## ***Interactive comment on* “Brief communication: Preliminary hydro-meteorological analysis of the flash flood of 20 August 2018 on “Raganello Gorge”, Southern Italy” by Elenio Avolio et al.**

Received and published: 14 May 2019

**We warmly thank the referees for their comments and their careful reading of our paper. Please find below our answers to all items raised (bold text).**

**Fig. 1.** On the left, Fig. 1c of the manuscript (24h accumulated precipitation according to the run RUN\_SST\_FC); on the right, the same but with improved soil moisture initialization.

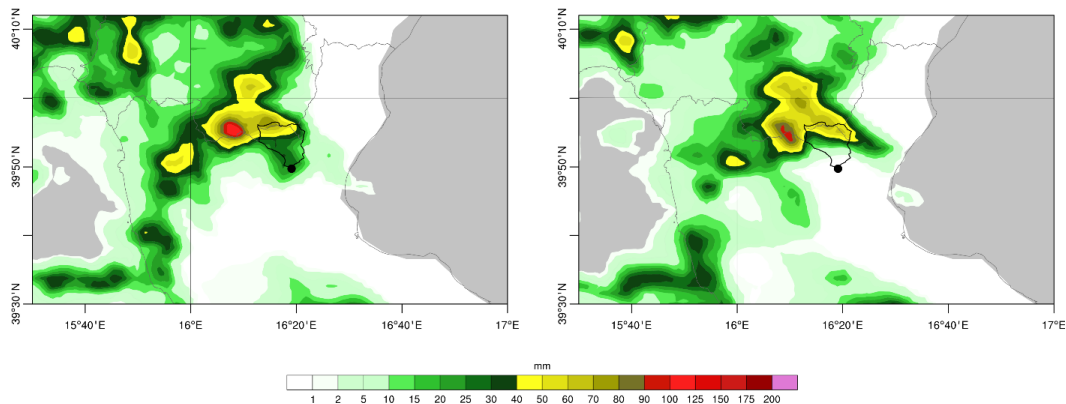
It seems that WRF initiates convection in a different location thus leading to the mismatch in positioning of the convective cell. Improved soil moisture initialization may help here.

**Such as pointed out in the manuscript (P8L11), future work will be performed in order to evaluate the possible role of soil moisture initialization. Also other causes can concur to the mismatch (e.g., too much smoothed elevation and slope of the mountain chain; effects of elevation representation will be also explored). However, since the topic of soil moisture initialization is addressed by both referees (please refer also to our response to referee 2 first comment), we were motivated to perform a preliminary test running a simulation with ERA5 re-analysis boundary conditions for the two weeks preceding the event; the soil moisture fields achieved were then used as initial conditions for our simulation. Preliminary results shown in Fig. 1 in this reply (please find it at the end of this document) seem to suggest that improved soil moisture initialization alone is not able to improve convective cell positioning. The issue of improved soil moisture initialization will be discussed with more details in the revised manuscript.**

**Fig. 2.** Hourly averaged rainfall values over the catchment and resulting hydrographs for radar-driven simulations and RUN\_SST\_FC.

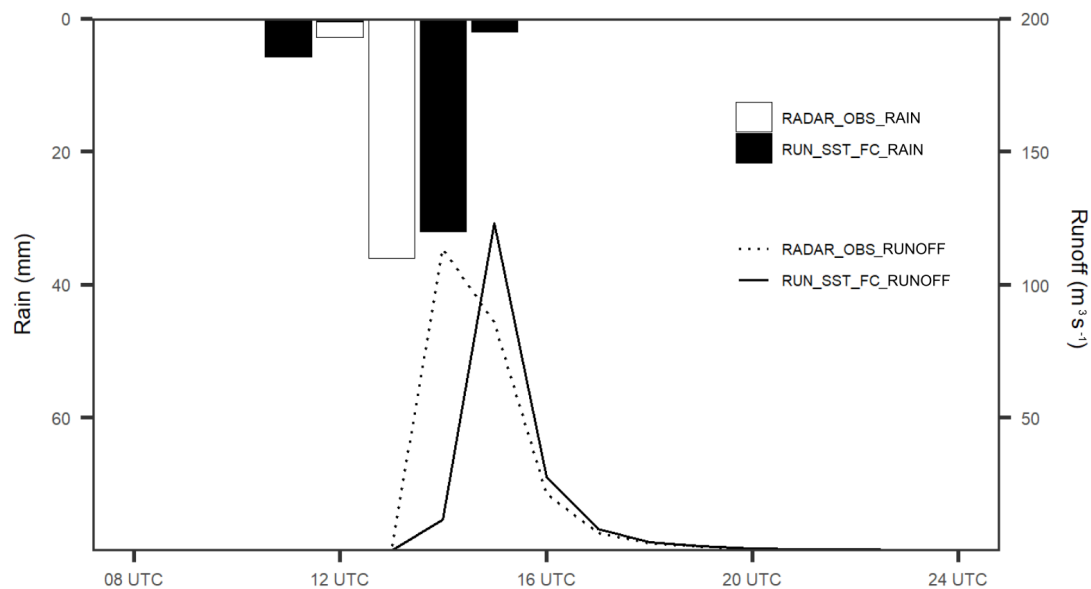
2) You do an interesting model setup intercomparison of coupled vs. non-coupled and variant surface boundaries vs. invariant but what is lacking is a comparison of the resulting hydrograph (figure 3) with one that has been modeled using the radar derived precipitation as input. One could disaggregate the SRT field with the assumption that a large portion of total aggregated rainfall occurred within the hour before the flood event.

4) In the following you reduce infiltration in the model (by setting REFKDT to 1.5) which leads to a higher discharge peak, but with the higher precipitation amount seen by the

radar also the original value of REFKDT = 3 could have led to similar outcome. That corroborates the need for a radar-driven simulation. How does the bias look like for the 10-13 UTC basin aggregated precipitation sums? To analyze this, the few pixels in Raganello creek catchment can be manually digitized to get the necessary information.

**We thank the referee for appreciating the model setup intercomparison and for the comment. We have followed his/her suggestion, even though acknowledging the related levels of uncertainty, and added a new resulting hydrograph in a new figure (we will replace the Fig. 3e in the revised paper), which is shown**

in our response to next point 4. The radar-derived precipitation has been transformed in WRF-Hydro input assigning to each pixel of the radar image a rainfall value equal to the central value of the corresponding colour class, then pixels have been aggregated from radar (1 km) to WRF (2 km) resolution by calculating the average. Temporal disaggregation has been made in proportion to the WRF output.

**The infiltration parameter REFKDT was reduced not with the aim of achieving a higher discharge peak (after all, this attempt would make no sense, because there is no observed peak for comparison), but because we took into account some intrinsic differences between one-way and fully-coupled versions of WRF-Hydro.**

**When WRF-Hydro is run in offline mode, the land model is called once per hour. In the fully coupled run, instead, the land model (and hence all the WRF-Hydro routines) is called on the WRF model physics time step, which is in the order of seconds. Such as Senatore et al. (2015) highlighted, *“the difference in land model execution frequency is important because it impacts how frequently infiltration and other fluxes are calculated. If the land model is called infrequently, then routed waters can travel farther downslope or into a channel before infiltration happens again. When the land model is called frequently, infiltration is calculated more frequently and thus more water infiltrates rather than making it all the way into a channel. Hence, more frequent land model calls usually result in more infiltration and less runoff, meaning also lower peak flows”*.**

**Therefore, REFKDT was reduced in order to compensate different intervals used for temporal integration of the Noah-LSM between the two versions of the model. This approach is supported also by the results achieved with the radar-driven simulation. Such as shown in Fig. 2 in this reply (which will be Fig. 3e in the revised paper), the one-way radar driven and the fully-coupled simulations have similar rainfall amounts in input. In order to get, such as expected, also similar discharge peaks, REFKDT is set equal to 3.0 (default value) in the one-way simulation and to 1.5 in the fully-coupled simulation.**
